### **AMENDMENTS TO THE DRAWINGS**

## **REMARKS**

Submitted with Response to Office Action  
dated December 28, 2005

The Applicants respectfully disagree. The device disclosed in Heinzen is represented in Figure 1 (set forth herein below).

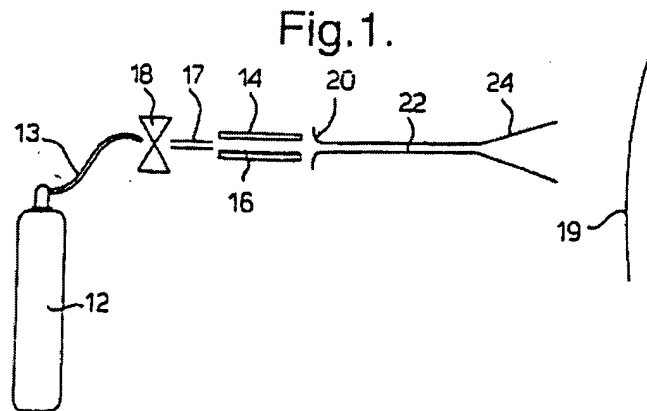
The Office Action acknowledges that establishing a quasi-steady flow upstream of a shock wave as well as entraining and accelerating particles in the quasi-steady flow is not taught by Heinzen. The Office Action, however, asserts that these elements are inherent to the device set forth in Heinzen. In support of this assertion, the Office Action states that Heinzen discloses the same structure as recited in the Applicants' claims and that due to this identity the Heinzen device will inherently function as the device claimed by the Applicants and therefore produce the associated waves and effects in use with shock waves.

The Office equates the tubing (13) that connects the compressed gas (12) to the membrane (18) of Figure 1 with the driver chamber (51) of Figure 5. The Office additionally equates the membrane (18) of Figure 1 with the closure means (53) of Figure 5, the acceleration chamber (22) of Figure 1 with the duct section (52) of Figure 5, the carrier particles (16) of Figure 1 with the dose of particles (58) of Figure 5 and the nozzle (24) of Figure 1 with the divergently contoured nozzle (54) of Figure 5.

The Heinzen device, on the other hand, is not configured in this manner. As can be seen with

reference to Figure 1, above, the carrier particles (16) are forward (i.e., downstream) of the tubing element (13; which the Office equates with the Applicants' claimed driver chamber) and membrane (18). Hence, when the membrane (18) is ruptured the particles (16) will be downstream of (e.g., in front of) the primary shock wave. Because the particles will be in front of the primary shock wave the flow produced will be different from that produced by the device claimed by the Applicants. Therefore, Heinzen does not teach or suggest a device that is constructed such that the opening of the closure means (e.g., 53) produces a primary shock wave which travels along the duct section (52) in a downstream direction so as to establish a substantially quasi-steady gas flow in the duct section upstream of the primary shock wave.

Additionally, as can be seen with reference to the above, the device disclosed in Heinzen does not have the same structure as recited in the Applicants' claims and therefore the Heinzen device will not inherently function as the device claimed by the Applicants and will not necessarily produce the same waves and effects. Hence, because these elements are not taught or suggested in Heinzen nor necessarily present therein, the cited reference is deficient in that it does not teach or suggest every element of the Applicants' claims. As Bellhouse '880 was cited for its disclosure of a "replaceable" particle containing capsule that includes particles sandwiched between two membranes and for its disclosure of a high pressure gas it fails to remedy the deficiencies of Heinzen.
